REVISIONS		CITY OF RIVERSIDE CALIFORNIA DEPARTMENT OF PUBLIC WORKS
MARK	DATE	
Rev. No. 1	9/28/62	RECORD OF SURVEY 646 SEWER, PLAN AND PROFILE OF INDUSTRIAL AVE - FREMONT ST TO JASMINE ST.
Rev. No. 1	Approved: <u>M. Matheis</u> Dir. of Public Works	
DESIGNED BY	CHECKED BY D.R.B. <u>wdg</u>	APPROVED BY <u>M. Matheis</u> DIRECTOR OF PUBLIC WORKS
DRAWN BY		DATE 2-28-62
RECOMMENDED BY <u>M. Matheis</u>	ASSISTANT CITY ENGINEER	SHEET 1 OF 3

REVISIONS		CITY OF RIVERSIDE CALIFORNIA DEPARTMENT OF PUBLIC WORKS	
MARK	DATE	DESCRIPTION	
Rev #1	5/28/62	Changed grade.	RECORD OF SURVEY 646
		George O. Crawley R.E. N° 9455	SEWER PLANS AND PROFILES ORDWAY ST. AND JASMINE ST FROM INDUSTRIAL AVE. SLY
Rev #1	Approved:	<i>Jim Matlock</i> Dir. of Public Works	APPROVED BY <i>Jim Matlock</i> DIRECTOR OF PUBLIC WORKS
DESIGNED BY	DRAWN BY	CHECKED BY D.R.B. WJG	APPROVED BY <i>Jim Matlock</i> DIRECTOR OF PUBLIC WORKS
RECOMMENDED BY		ASSISTANT CITY ENGINEER	DATE 2-28-62

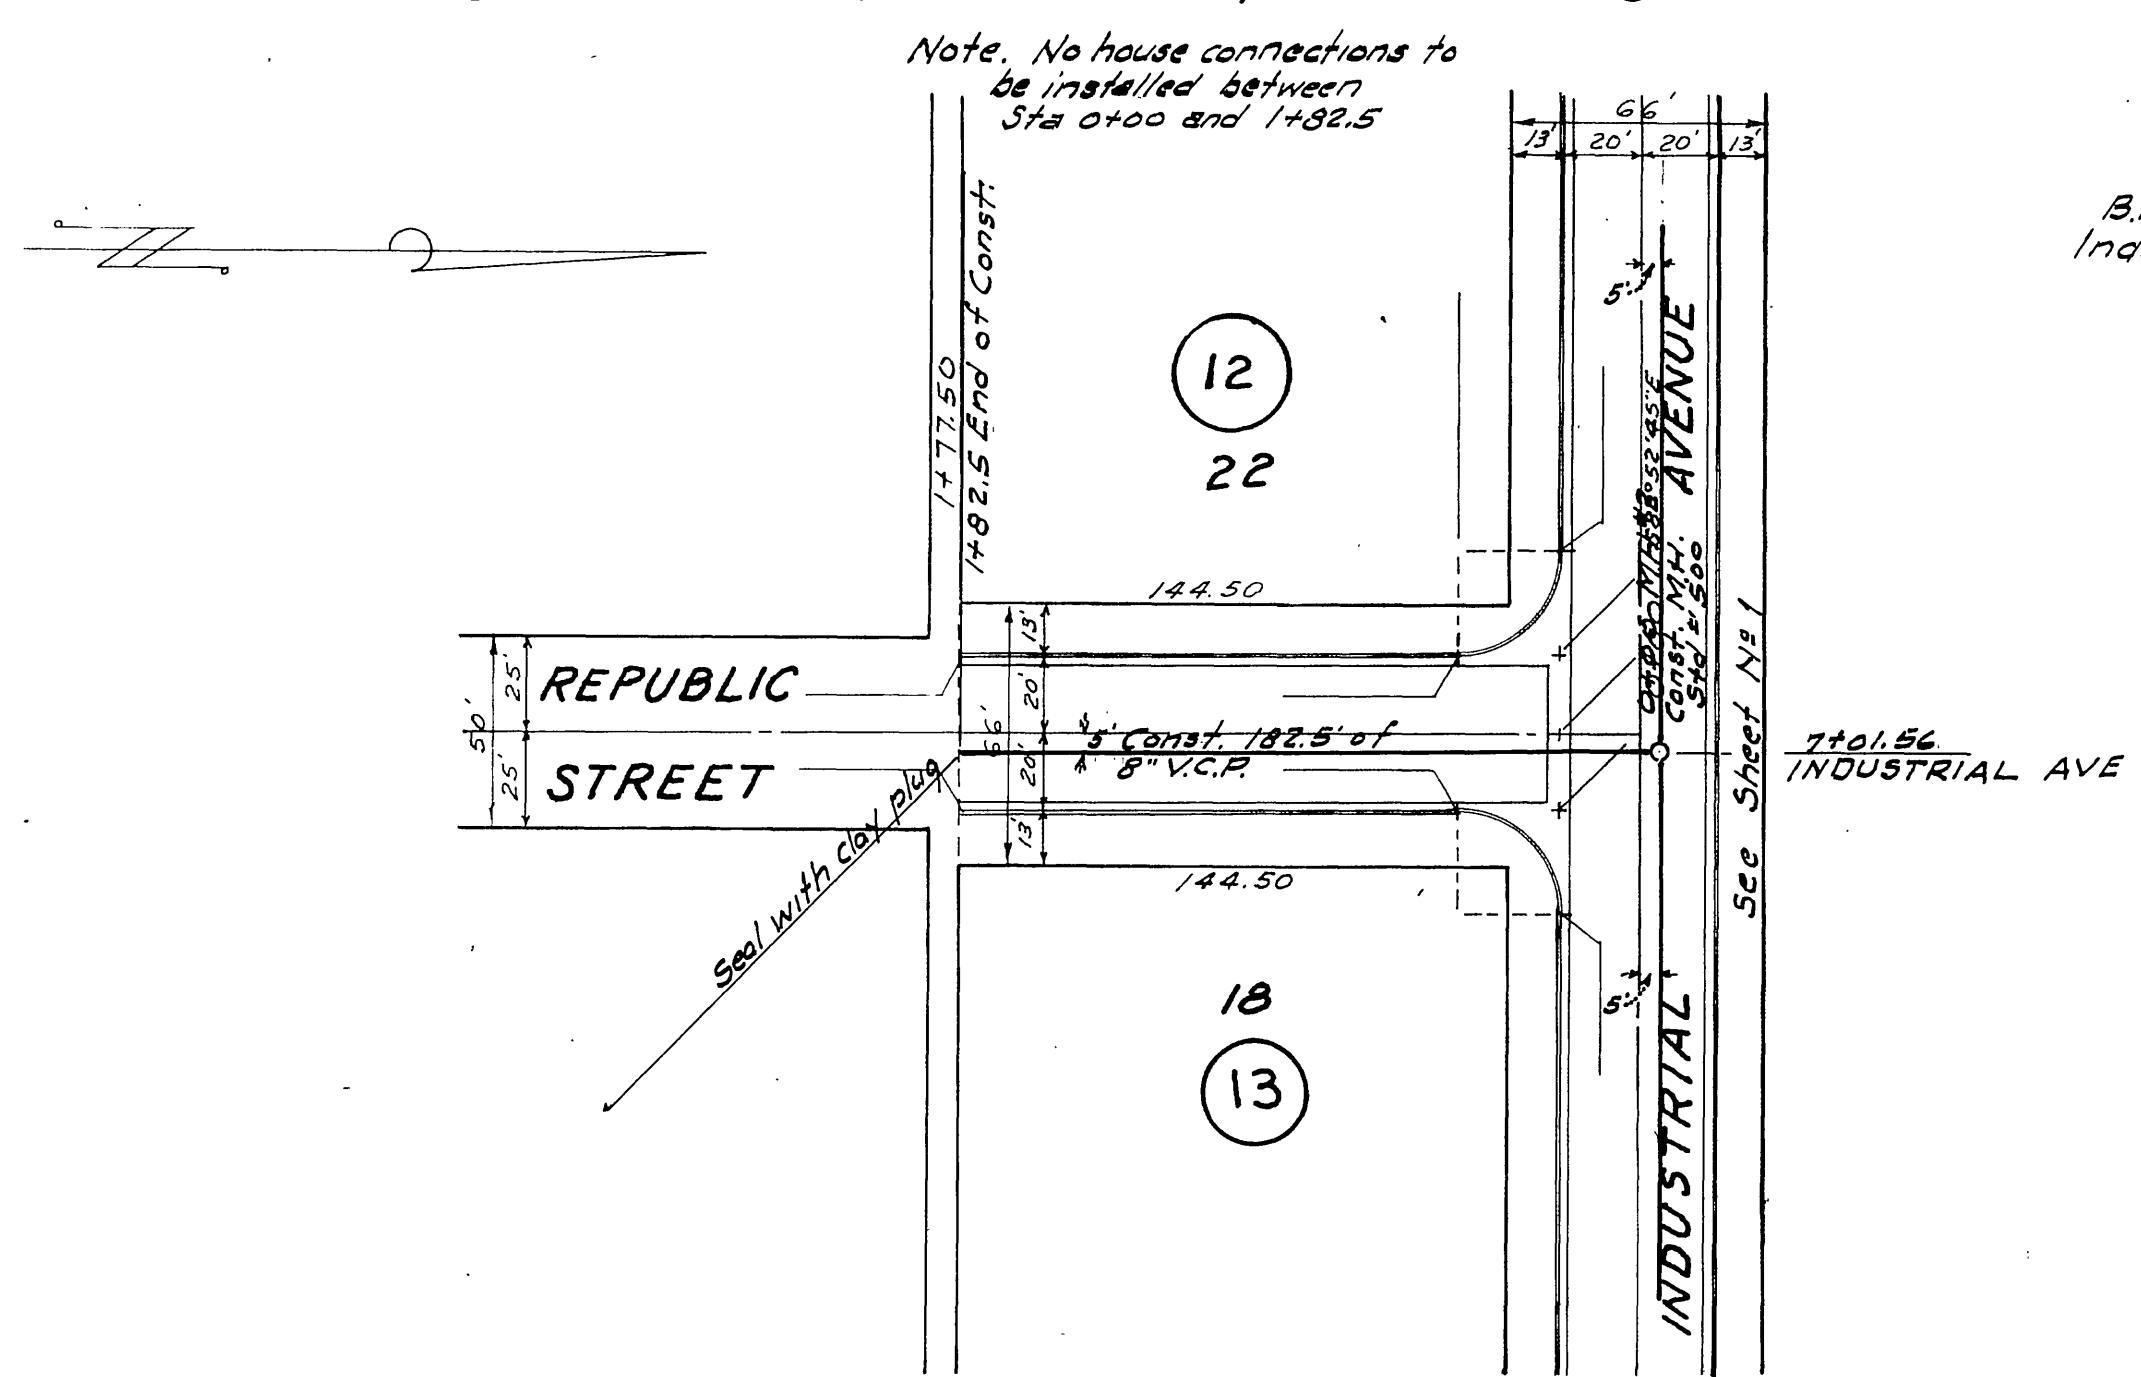
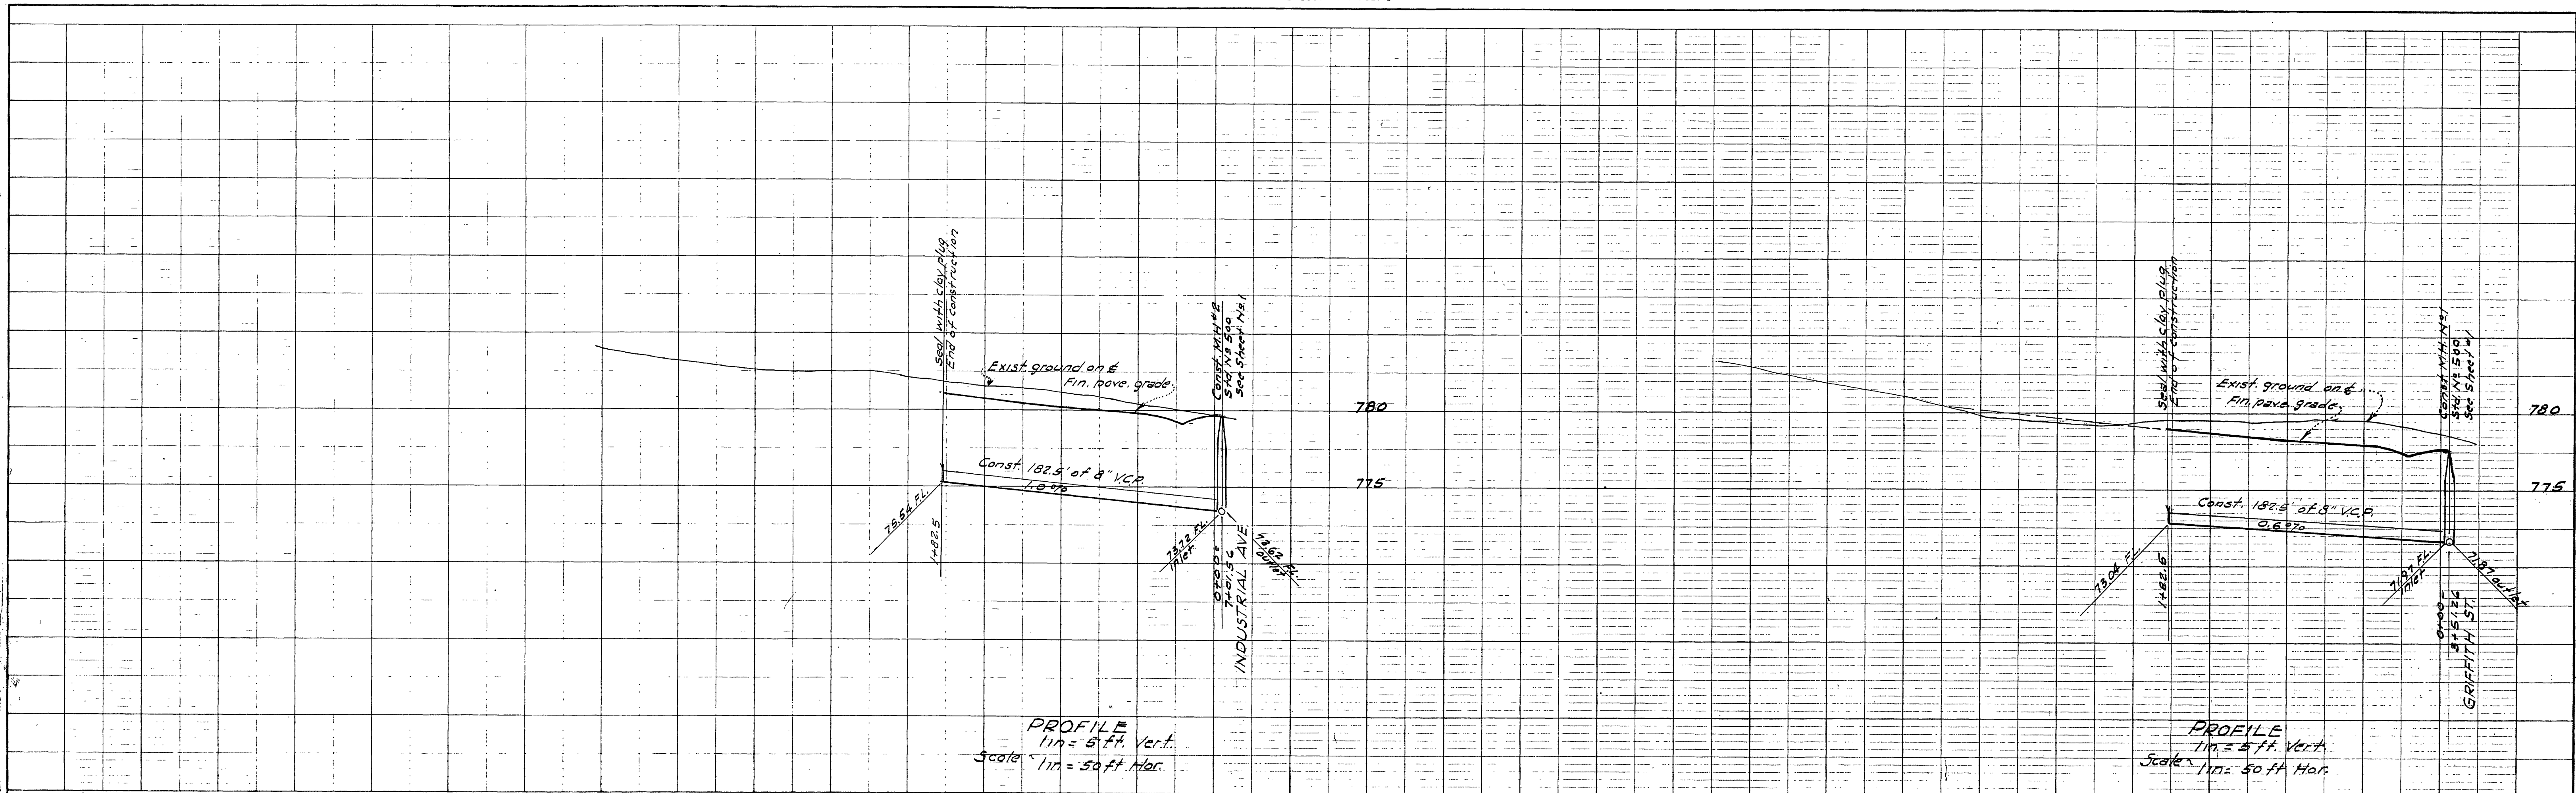
Form M.H. bottom to receive flow from Jasmine Street and install 8" V.C.P. stub. Flow line elev. 779.30

NOTE:
 As of this date, August 3, 1962
 All sewer appurtenances easterly of Sta. 12+50 are existing.
 This project requires the extension of 151.69 feet of 8" V.C.P. westerly between existing M.H. #4 and proposed M.H. #5 at Jasmine St.

APPROVED FOR 151.69' SEWER EXTENSION AND MANHOLE
 BY M. Matheis DATE 8-3-62
 DIRECTOR OF PUBLIC WORKS
